AGENDA
BIRMINGHAM DESIGN REVIEW BOARD
WEDNESDAY DECEMBER 7, 2022
BIRMINGHAM CITY HALL, 151 MARTIN ST, COMMISSION ROOM 205, BIRMINGHAM MI *
******* 7:15 PM*******

SUBJECT: 34040 Woodward – Community Unity Bank – Design Review

The applicant has submitted a Design Review application for a sign and façade changes on an existing 1-story commercial building in the B2 General Business and MU-5 Triangle District Overlay zoning districts. The subject site is located on the east side of Woodward, north of Lincoln St.

A-500
EXTERIOR SIGNAGE
AND DETAILS

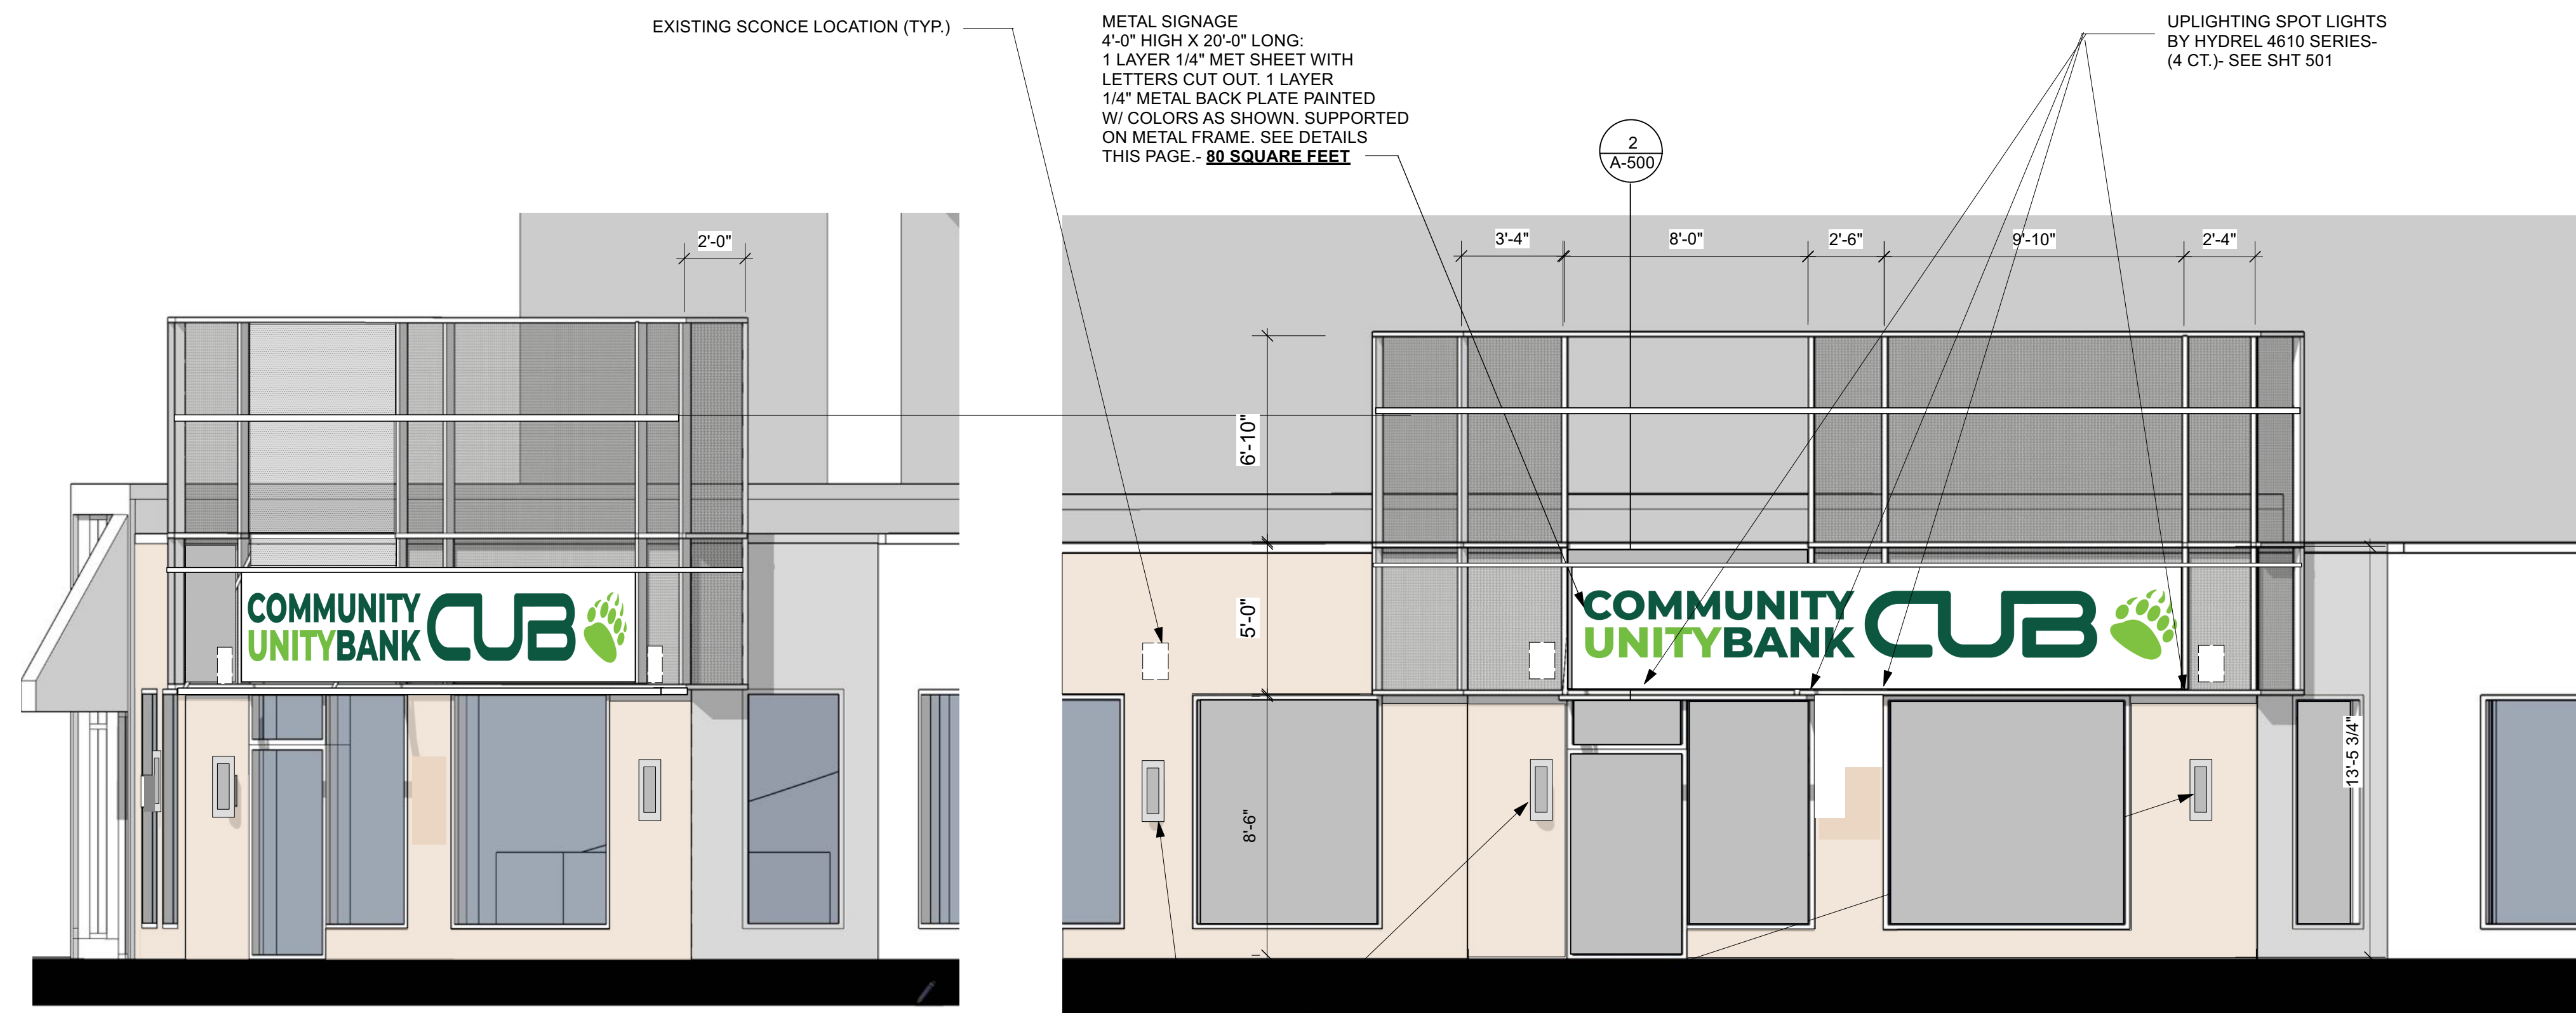
As this building is located within the Triangle District Overlay District, there are specific architectural standards that must be followed. Per Article 3.09, Section (D) (1) of the Zoning Ordinance, “all walls exposed to public view from the street, or parking area shall be constructed of not less than 60% brick, stone or glass.” The architectural feature is proposed to be of a mesh

metal material, but does not appear to bring the portion of the building constructed of brick, stone or glass, under 60%. The plan appears to meet all relevant standards under Article 3.09.

The total area of the proposed sign is 80 sq. ft. and the sign is proposed to be mounted in the sign band. The total linear building frontage for this tenant is 53.5 ft. on Woodward, which means that the total allowable combined sign area for this tenant is 80.25 sq. ft. It is worth noting that the plans are inconsistent in some areas after revisions, which will need to be updated.

The proposed Hydrel spotlight light fixtures are not full cutoff as defined in Section 9.02. **Thus, the Design Review Board should discuss the proposed fixtures in regards to the six conditions listed above and determine if an exception will be granted.**

The 5 proposed Scott Arch. Lighting sconces will be replacing existing wall lights. The new wall sconces will be positioned lower on the wall. There are no dimensions included for height from grade, however the specification sheet shows the depth projection to be 4". **The applicant must submit revised plans to show the height from grade for the light fixtures.**

Based on the requirements of Article 7, Section 7.09, the Planning Division recommends that the Design Review Board **APPROVE** the Design Review application for 34040 Woodward – Community Unity Bank – with the following conditions:

1. The applicant must submit revised plans with consistent signage details;
2. The Design Review Board APPROVES the non-cutoff light fixtures pursuant to Article 4, Section 4.21 (D) of the Zoning Ordinance;
